SPECTRO3-ANA-Scope: Changes due to software update from SPECTRO3-ANA-Scope V1.2 to V1.3

The text below summarises the changes that were made with the software update from **SPECTRO3 ANA V1.2** to **V1.3**.

Change 1:

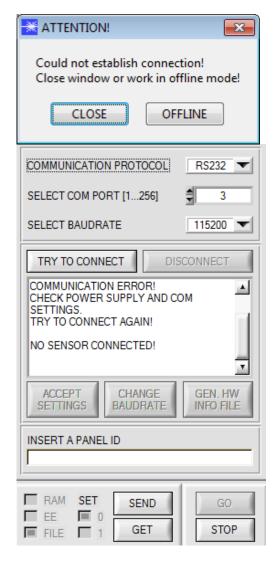
If a connection is not established automatically, e.g. if no sensor is connected, the software can be run in OFFLINE mode. In offline mode it only is possible to exchange parameters with a file on a storage medium, which often is helpful for the purpose of analysing parameter files.

If a sensor is connected and a connection still cannot be established, either the SCOPE version (program on the PC) and the firmware version (program in the sensor) do not match, or the interface to the sensor must be correctly configured.

If different Scope and firmware versions should be the problem, please get the Scope version that matches the firmware from your supplier.

Change 2:

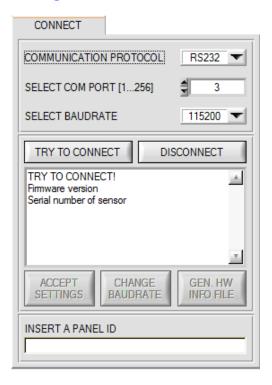
When a connection is established the serial number of the contacted sensor is transferred in addition to the firmware version.

The baudrates have been extended with 230400 and 460800.

DISCONNECT disconnects the connection between sensor and PC. The software then switches to OFFLINE mode, where it is only possible to exchange parameters with a file on a storage medium.

The interface is then free for other programs (e.g. FirmwareLoader).
